**Freightliner
Service Bulletin**

Water Leaks Between Rain Tray and Nosebeam, New Cascadia

60-162

Fig. 4, Foam Tape Application

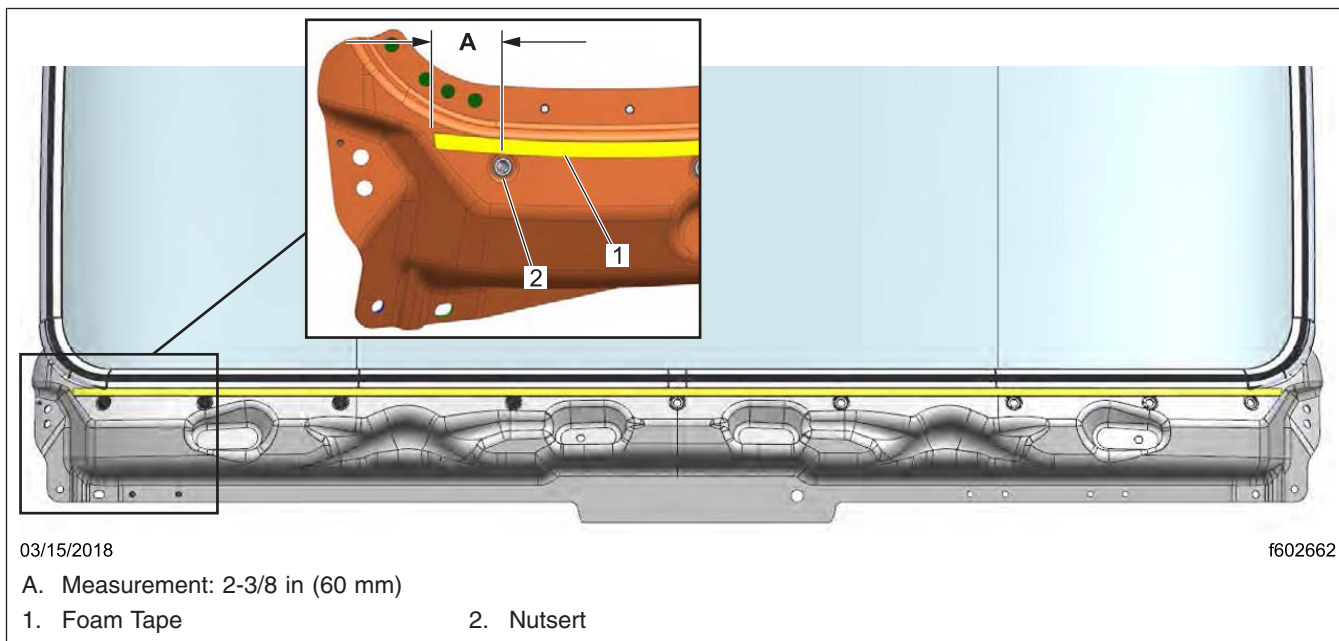
On some New Cascadia vehicles, the rain tray can warp and leave gaps, which can allow water to get past the seal and leak down the front wall. From March 21, 2018, foam tape has been installed between the rain tray and the nosebeam to prevent water leaks. On vehicles built before March 21, 2018, if water is found to get past the rain tray, use the procedure in this bulletin to install the foam tape.

6. On the passenger side, remove the screws that attach the cowl panel to the end of the rain tray and the hood support.
7. Remove the screws that attach the rain tray to the cab front wall.
8. On the passenger side of the vehicle, pull the cowl outboard and remove the rain tray.
9. Apply foam tape to the nosebeam as shown in [Fig. 4](#) and [Fig. 5](#). Align the tape along the tops of the nosebeam nutserts, extending 2-3/8 in (60 mm) outboard of the outboard nutserts on both sides of the vehicle.
